# UNITED STATES PATENT AND TRADEMARK OFFICE

APPLICATION NO.	FILING DATE	FIRST NAMED INVENTOR	ATTORNEY DOCKET NO.	CONFIRMATION NO.
10/553,832	10/20/2005	Mario Giorgio Prussiani	2502-1089	6302
466	7590	10/01/2007	EXAMINER	
YOUNG & THOMPSON			SCRUGGS, ROBERT J	
745 SOUTH 23RD STREET			ART UNIT	PAPER NUMBER
2ND FLOOR			3723	
ARLINGTON, VA 22202			MAIL DATE	DELIVERY MODE
			10/01/2007	PAPER

<b>Office Action Summary</b>	Application No.	Applicant(s)
	10/553,832	PRUSSIANI, MARIO GIORGIO
	Examiner	Art Unit
	Robert Scruggs	3723

FIG. 5

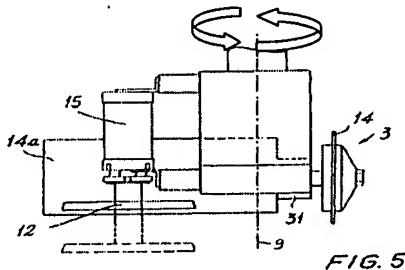
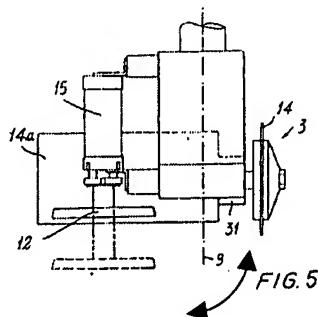
2. The drawings are objected to under 37 CFR 1.83(a). The drawings must show every feature of the invention specified in the claims. Therefore, the cutting head rotating about the third axis must be shown or the feature(s) canceled from the claim(s). No new matter should be entered.

4. Claims 19-43 are **Finally rejected** under 35 U.S.C. 112, second paragraph, as being indefinite for failing to particularly point out and distinctly claim the subject matter which applicant regards as the invention. Claims 19 and 33 disclose the limitation that the cutting head rotates about said third axis. Is the applicant trying to disclose that the entire cutting head (3) of the device rotates around axis (9) as shown below?

Or is the applicant trying to disclose that the cutting head (3) rotates (or pivots) about the axis (9) also shown below? The examiner is confused as to the exact movement that is taking place and therefore believes the claims are indefinite.

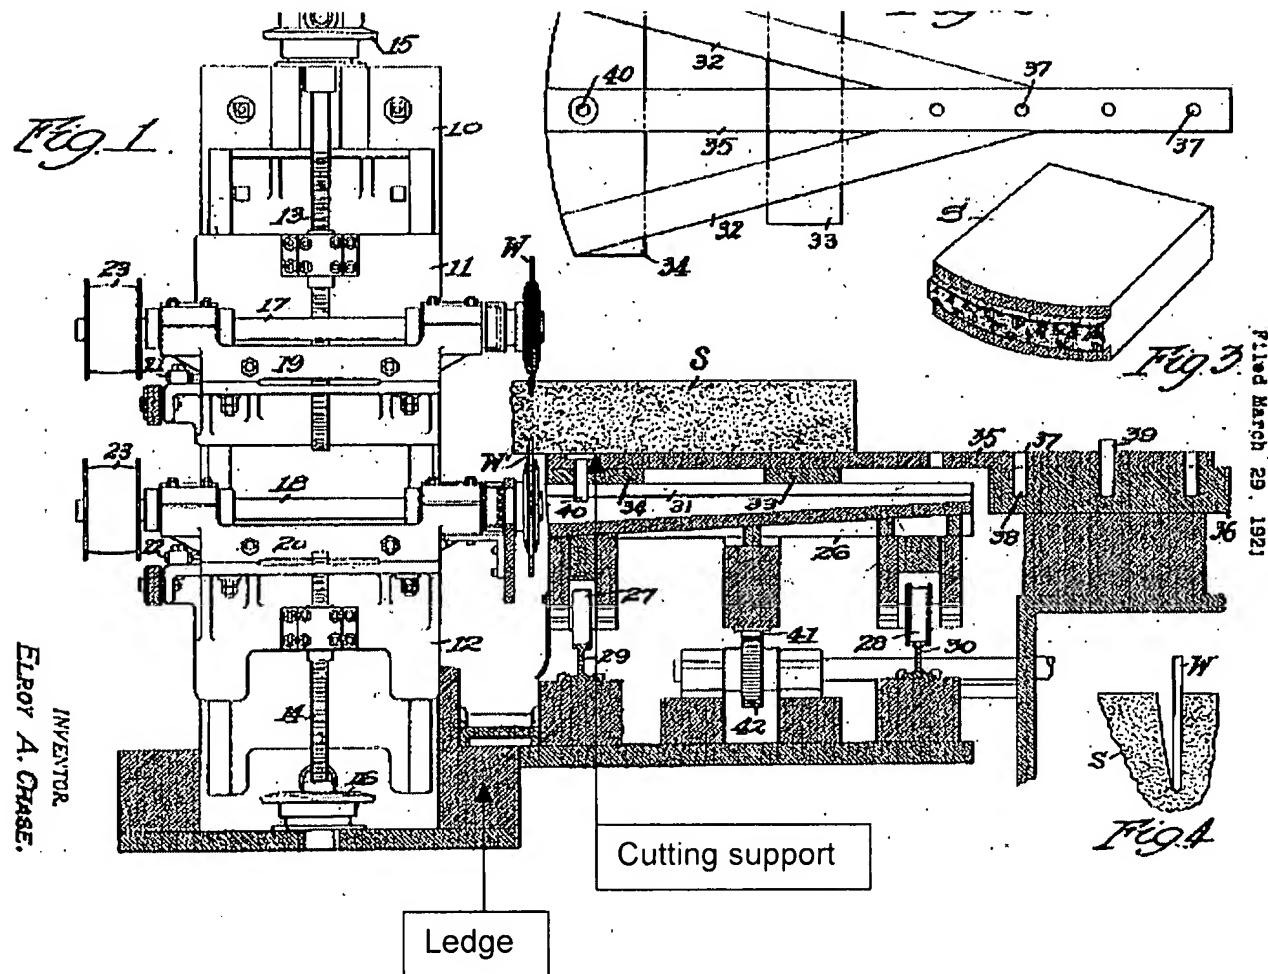
In reference to claims 28 and 40, Bando discloses the claimed previously mentioned above, but lacks, a cutting disc disposed to a side of the cutting support. However, Chase discloses a cutting disc (W') disposed to a side of the cutting support (See figure below). It would have been obvious to one of ordinary skill in the art at the time the invention was made to modify the device, of Bando, with lower cutting disc, in view of

In reference to claims 31 and 43, Chase also discloses that the vertical guides are fixed to a ledge projecting from said support (see figure above).

In reference to claims 28 and 40, Christian discloses the claimed previously mentioned above, but lacks, a cutting disc disposed to a side of the cutting support. However, Chase discloses a cutting disc (W') disposed to a side of the cutting support (See figure above). It would have been obvious to one of ordinary skill in the art at the time the invention was made to modify the device, of Bando, with lower cutting disc, in view of Chase, in order to cut different sections of a workpiece simultaneously thereby increasing productivity and efficiency.

In reference to claims 31 and 43, Chase also discloses that the vertical guides are fixed to a ledge projecting from said support (see figure above).
